Vogtle Project

NRC DOCKET NUMBER 50-425
CONSTRUCTION PERMIT NUMBER CPPR-109
VOGTLE ELECTRIC GENERATING PLANT - UNIT 2
TECHNICAL SPECIFICATIONS

TECHNICAL SPECIFICATIONS
Vogtle Electric Generating Plant,
Units 1 and 2
Dockets 50-424 and 50-425

INDEX OF AFFECTED PAGES AND JUSTIFICATIONS

FIGURE 3.4-2

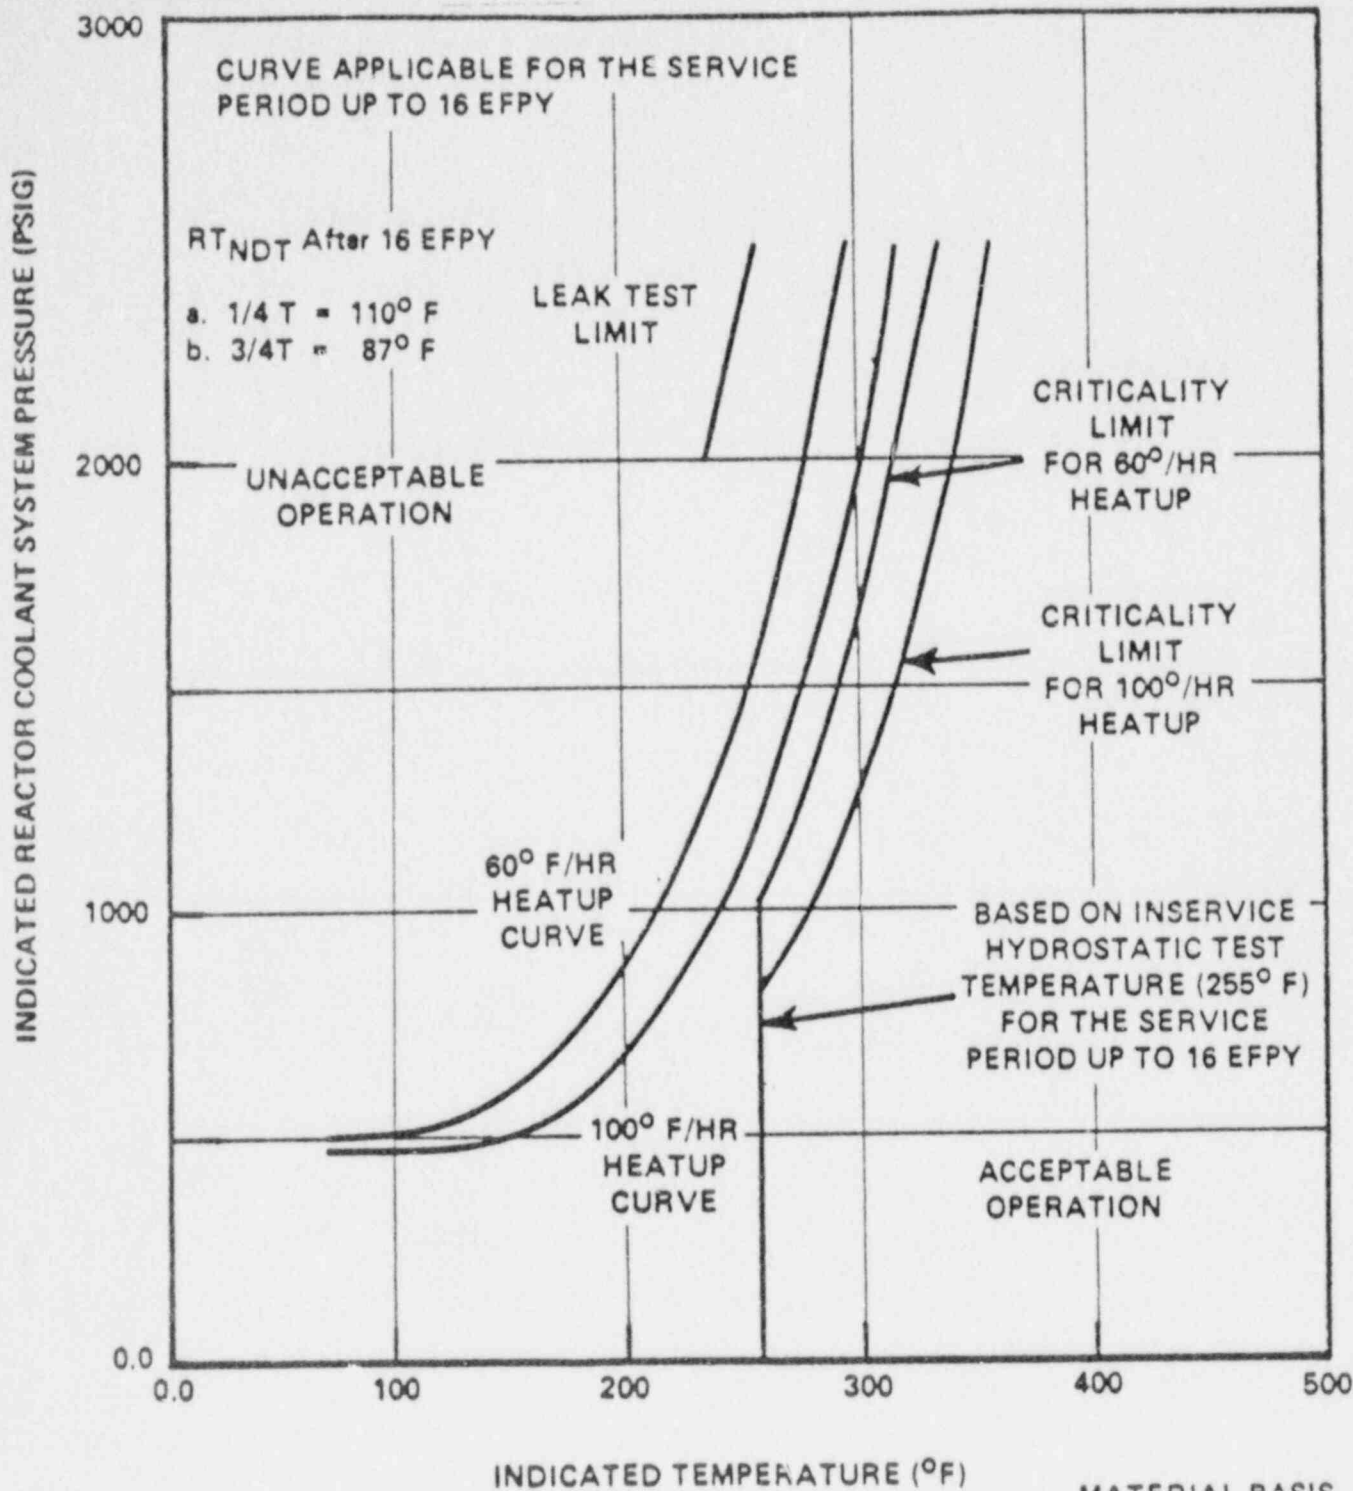
TO BE REVISED TO REFLECT UNIT 2

FIGURE 3.4-4

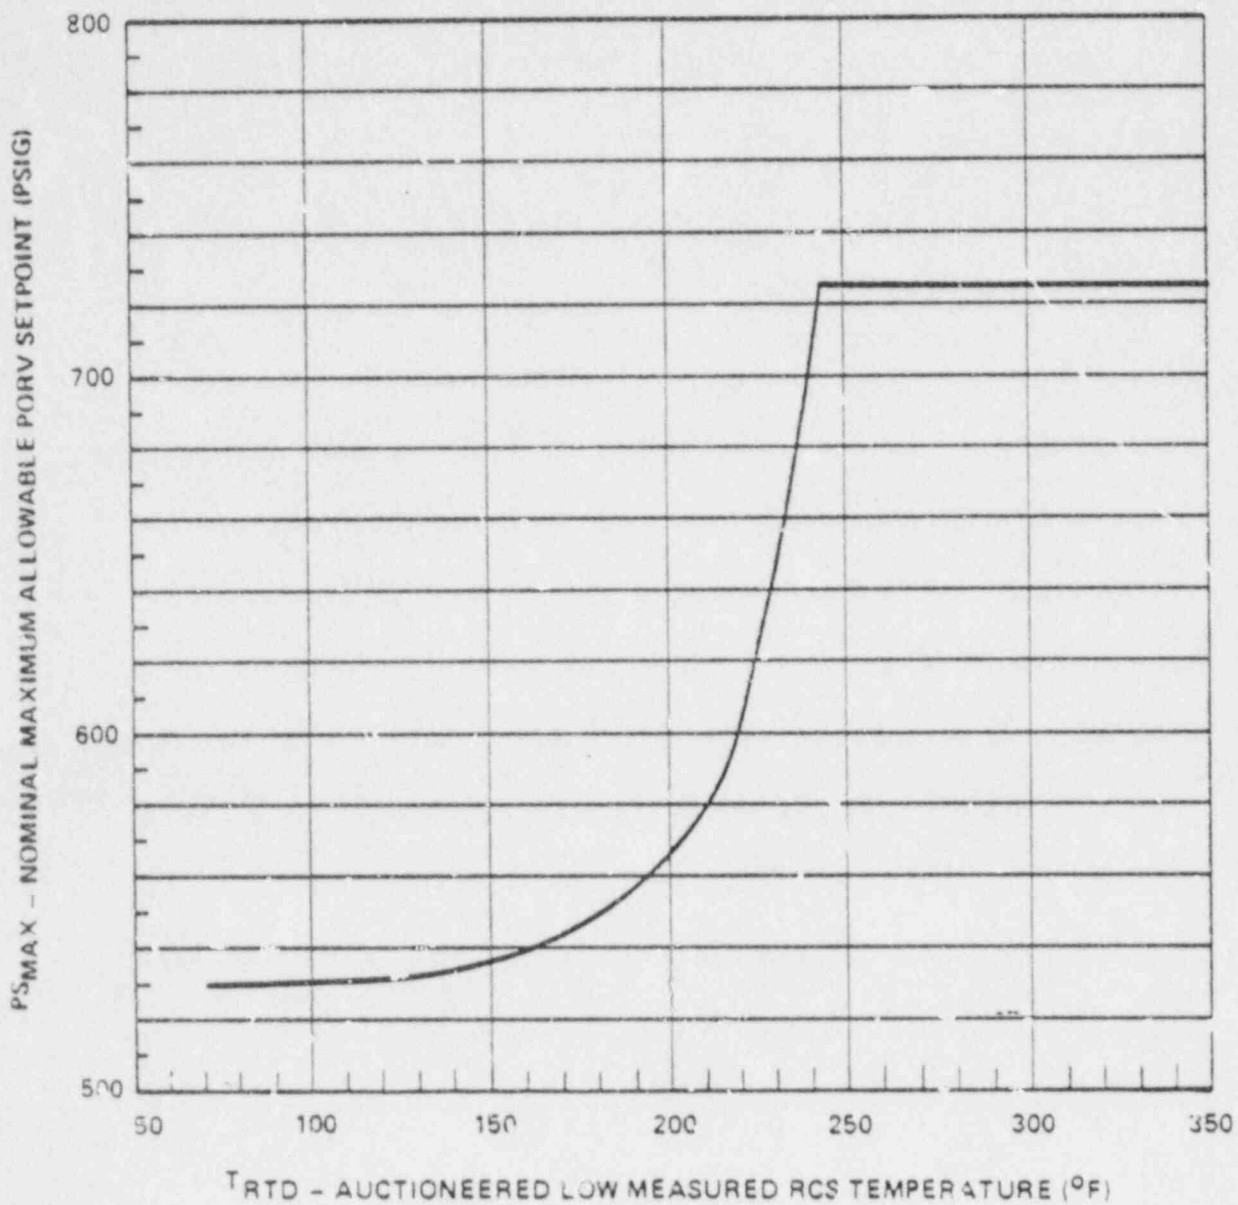
TO BE REVISED TO REFLECT UNIT 2

FIGURE 6.2-1
OFFSITE ORGANIZATION

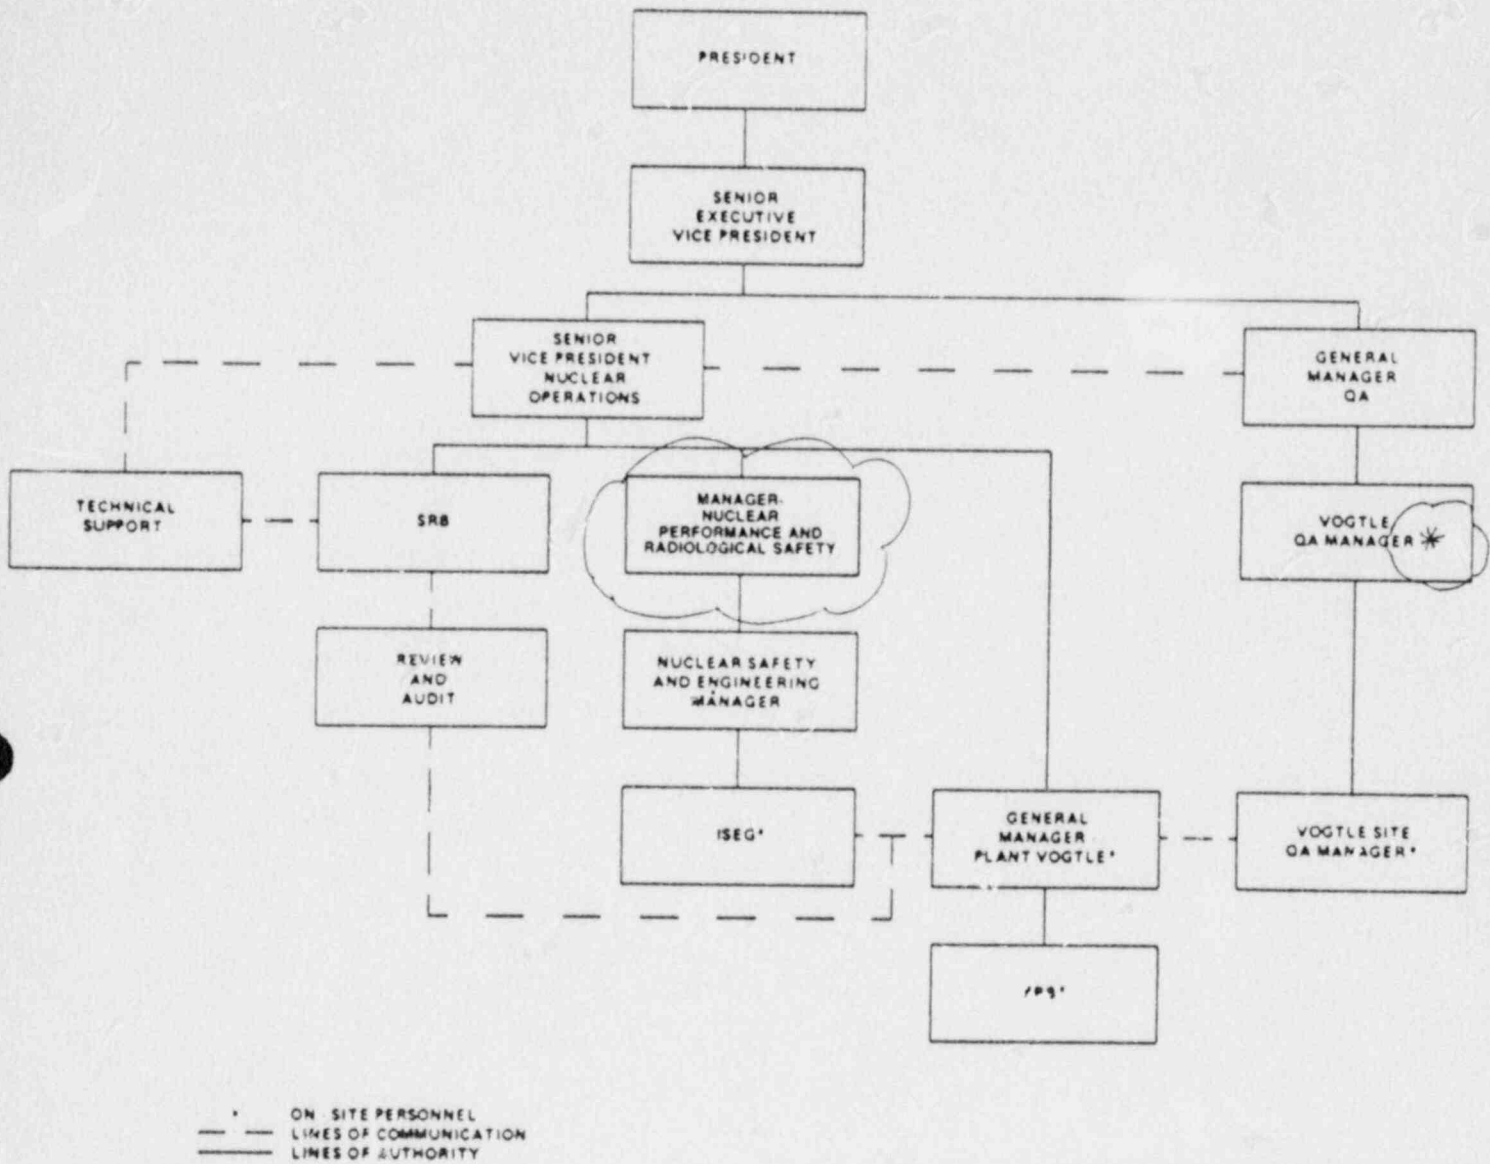
On Figure 6.2-1 and page 6-6 change the title of Manager-Nuclear Performance and Analysis to Manager-Nuclear Performance and Radiological Safety.

FIGURE 6.2-2

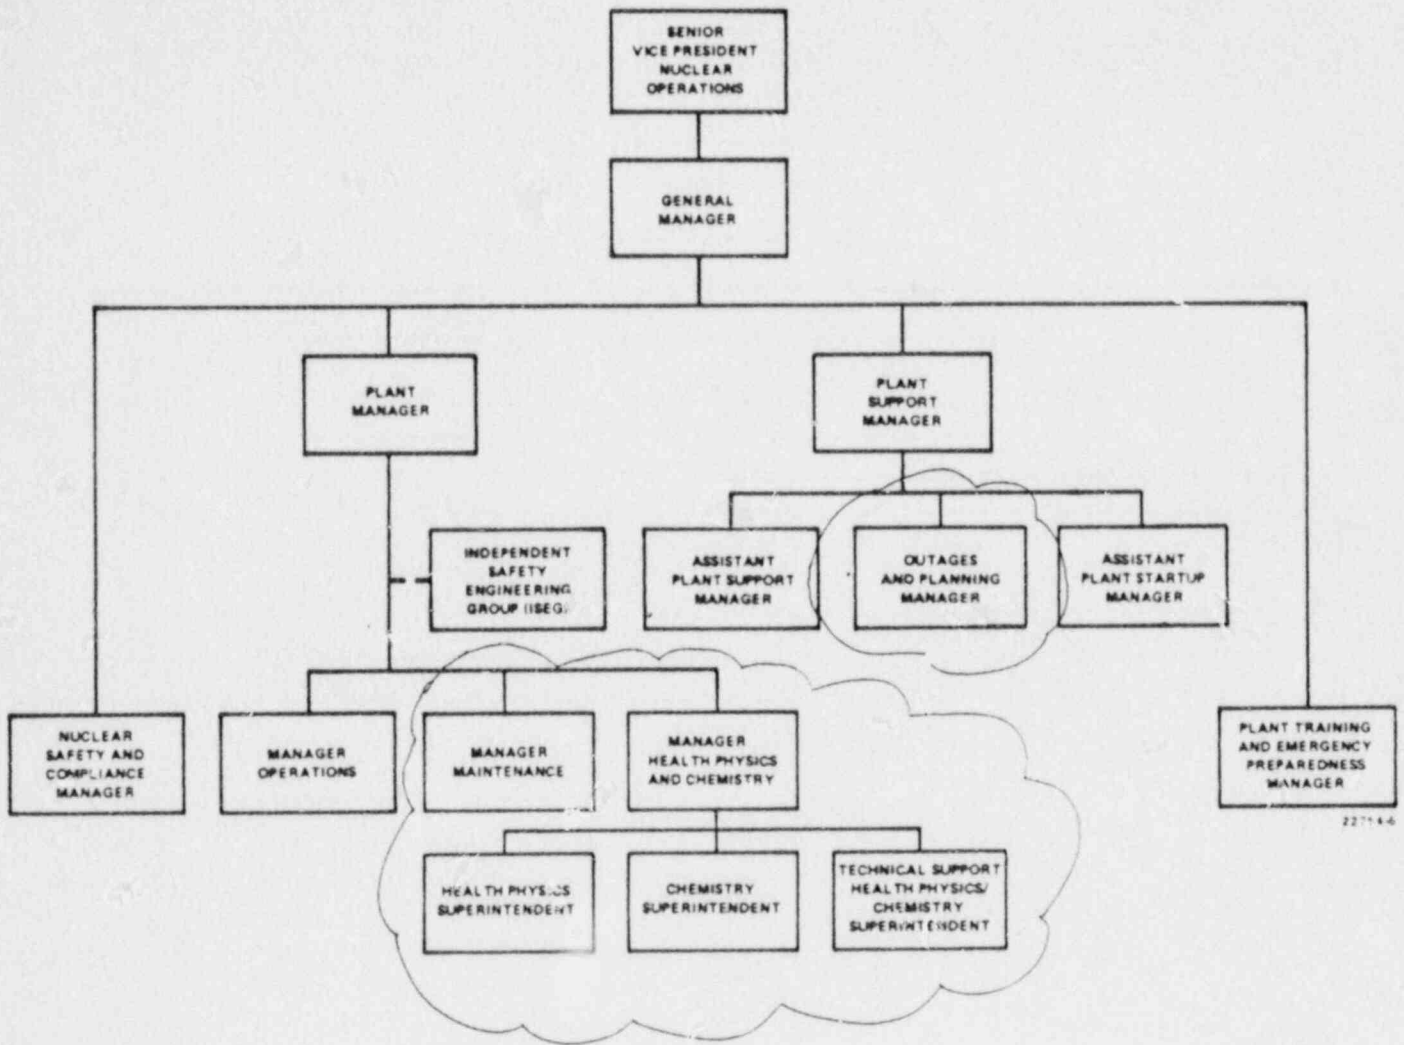
On Figure 6.2-2 add the new position of Outages and Planning Manager reporting to the Plant Support Manager. Delete the Unit 1 Planning, Scheduling, and Work Control Methods Superintendent. Change the title for the Maintenance Superintendent III position to Manager Maintenance. Add the new position of Manager Health Physics and Chemistry, who has authority over the Health Physics Superintendent, the Chemistry Superintendent, and the new position of Technical Support Health Physics/Chemistry Superintendent.
